DOCKETED	
Docket Number:	24-OPT-05
Project Title:	Corby Battery Energy Storage System Project
TN #:	272425
Document Title:	Michael Geller Comments - Comments on Staff Assessment Section 514 Transportation
Description:	N/A
Filer:	System
Organization:	Michael Geller
Submitter Role:	Public
Submission Date:	9/10/2026 7:52:26 AM
Docketed Date:	9/10/2026

Comments on Staff Assessment Section 514 Transportation

Transportation Analysis Deficiencies Under CEQA

Corby BESS Project

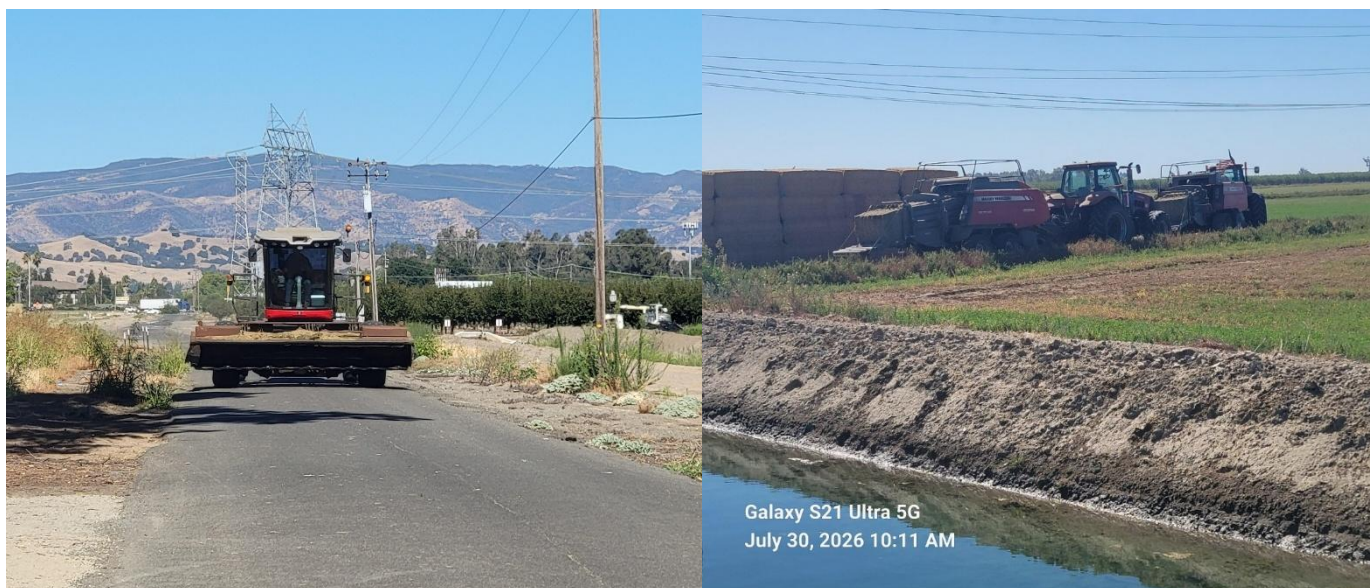
The photograph below documents agricultural harvesting operations occurring within the Project vicinity during preparation of these comments. The exhibit illustrates that agricultural activity is not hypothetical or seasonal speculation; it represents an existing and continuing use of the transportation corridor.

Recent photographs from the Project vicinity depicts large tractors and hay-baling equipment operating adjacent to irrigation canals and embankments. These vehicles occupy significant roadway width and maneuver slowly. Their presence confirms that agricultural transportation is an existing, continuous, and foreseeable roadway use, not a hypothetical condition. The interaction between these vehicles and heavy-haul construction traffic—including gen-tie line construction vehicles—must be evaluated under CEQA. Section 5.14 does not contain substantial evidence demonstrating that such interaction has been analyzed.

The agricultural equipment photograph also illustrates irrigation canals, embankments, and narrow shoulders that limit maneuverability. These physical constraints exacerbate conflicts between agricultural vehicles, construction traffic, emergency responders, and school transportation. Section 5.14 does not evaluate how these constraints affect combined operational demands during peak construction activity or gen-tie line construction.
